SERVICE BULLETIN

Date: March 18, 1994

Units Affected: Ampeg SVT-III & AP-3550  
All units, domestic and export.

Subject: Possible shock hazard under some conditions.

SVT-III

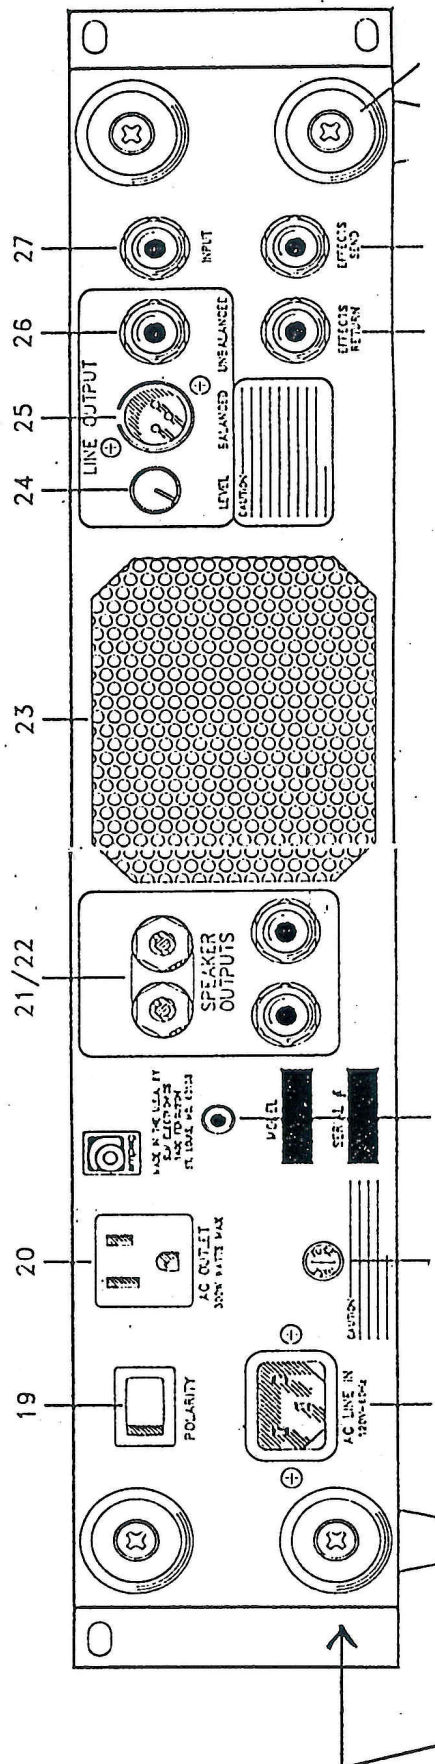
Some units were built with too long a screw used to attach one of the large plastic feet to the rear panel (not the smaller rubber feet on bottom of unit). The screw in question is the one that attaches the large plastic foot nearest the line cord input connector on the rear chassis panel. (See drawing page 2.) This is the lower left foot if facing the rear panel of the unit. (Not the rubber feet on bottom of unit.) The possibility exists of this screw coming in contact with the internal Faston connector which is connected to the AC Neutral input of the unit.

If the AC outlet where unit is plugged in is wired per code (U.S. units) the hazard is minimal. The real concerns are overseas units and buildings in the U.S. not wired per code in such a way that AC Line and Neutral are reversed (as sometimes happens in older buildings). The chassis of these units could be at AC line potential if the screw were indeed touching the internal Faston in these cases.

Facing the rear of the unit, remove the lower left foot screw and discard. Re-attach the foot using a # 8-32 3/4" screw (30-833-75) and a # 8 washer (30-835-01). Please see enclosed pictorial.

1) FACING REAR OF THE UNIT - REMOVE SCREW FROM LOWER LEFT FOOT AND DISCARD.

2) RE-ATTACH FOOT USING # 8-32 3/4" SCREW (30-833-75) AND A # 8 WASHER (30-835-01).
